GAS TANK VALVE / ALL MODELS

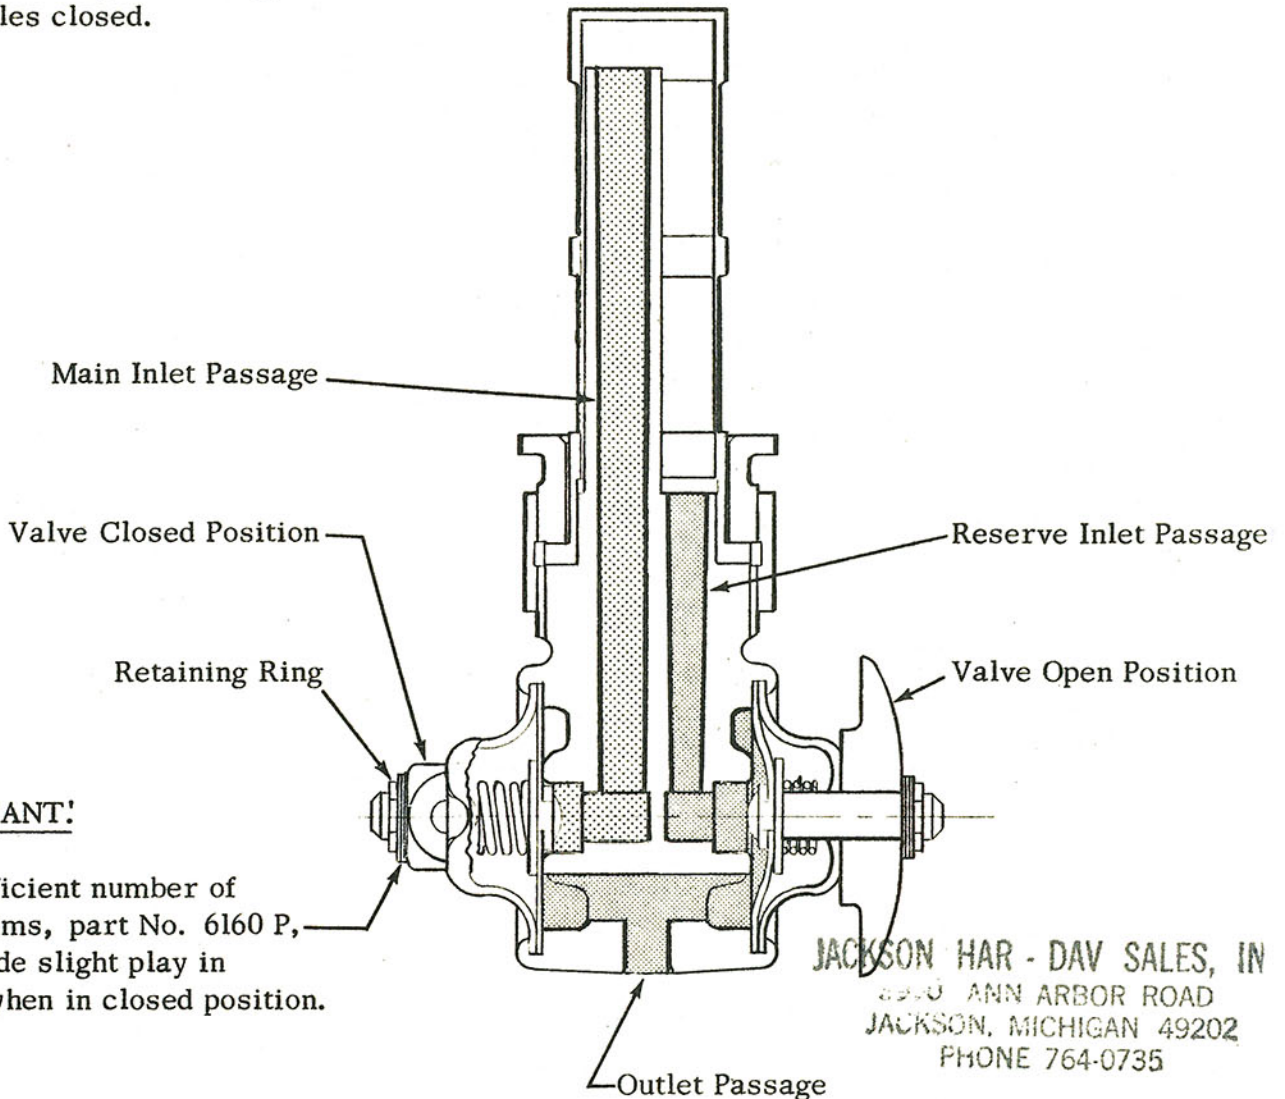
If the handle is too loose on diaphragm type fuel tank valves, it will not allow full flow of gasoline to the engine. This can result in engine slowdown because of insufficient fuel supply at high speed.

There should not be more than .010 in. clearance between the lock ring and handle when the valve is in the closed position. If there is excessive clearance, add enough .006 in. thick shims, part No. 6160 P, to provide only slight clearance when valve is closed. This will give the maximum diaphragm opening when the valve is turned on. See illustration below. After any shimming, check to see that valve does not leak fuel from outlet with both handles closed.

Add sufficient number of .006 shims, part No. 6160 P, to provide slight play in handle when in closed position.
